NAME Skyline Heights Addition

S/D 59-33 SKYLINE HEIGHTS ADDITION
E OF HOOVER BET 37TH ST S & MACAR-
THUR MOEHRING J-1

SUBDIVISION PROGRESS SHEET

Subject: S/D 59-33 - Final Plat of Skyline
Heights Addition

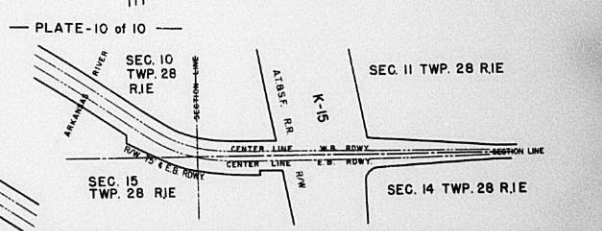
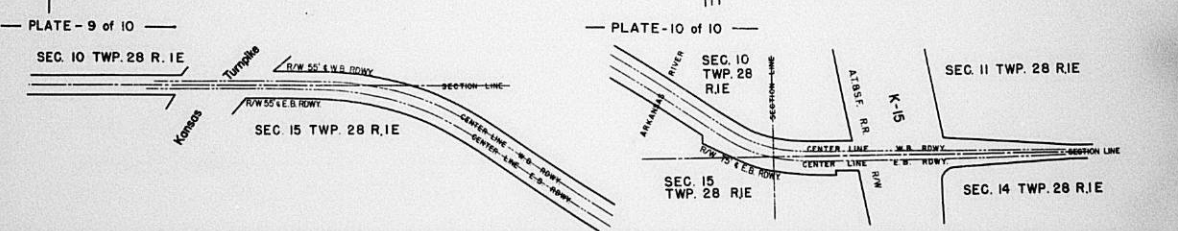
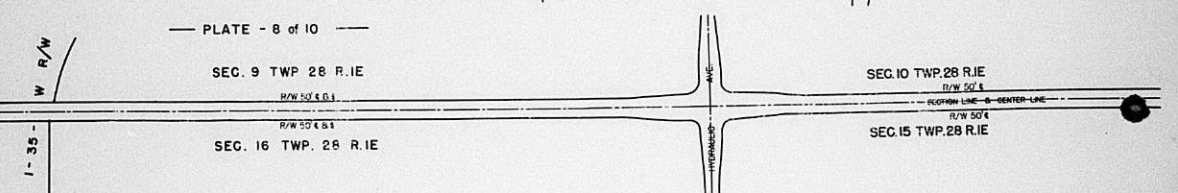
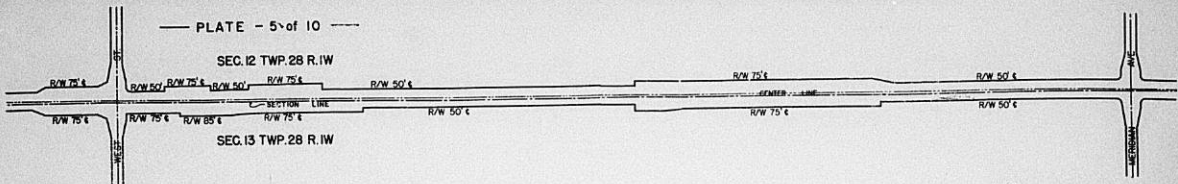
As requested in your recent phone call we are enclosing a blueprint of the tentative plan sheet covering that portion of MacArthur Road at the Hoover Road intersection and adjacent to the proposed Skyline Heights subdivision at the northeast corner of the intersection.

As you will note, the proposal is that west of Hoover the full right-of-way would be to the south of the existing north right-of-way line; the proposed new construction would therefore be actually all to the south of the present road except as the north (west bound) lane swings to the northeast of Hoover to cross a proposed new bridge across the floodway channel.

We are also enclosing a sketch to a larger scale of the stretch of road immediately south of the proposed subdivision to indicate what we would like to suggest might be done in way of access roads.

Flora Street as tentatively platted would, if allowed to run into MacArthur, meet the road almost at the end of the left-turn lane for west bound traffic. While this would not be too terrifically objectionable it would still be closer to the intersection than we would like to see a road if it is possible to avoid it. We should like to suggest, or at least discuss the possibility, of limiting access to this area to an intersection at approximately the location of the proposed Skyview Street which would be far enough back from the Hoover Road intersection so as not to cause any interference with the traffic at the intersection. At this point a full intersection could be constructed with left and right turn lanes to make it as easy as possible to turn from either lane of MacArthur Road into the new area. It occurs to us that it also might be possible to make this the point of access to the area south of MacArthur Road whenever that is platted.

This sketch also indicates another point; that the construction as presently proposed for MacArthur would not actually require all the right-of-way which now exists along the north side of the road east of Hoover. For that reason if this plan is adopted for the construction of MacArthur Road it would be

possible, it seems to us, to permit use of part of the existing right-of-way, for at least a part of the length of the subdivision, to be used as part of a frontage road for the subdivision in case that arrangement would be of any help in negotiating with the property owner for limiting access to MacArthur as proposed.
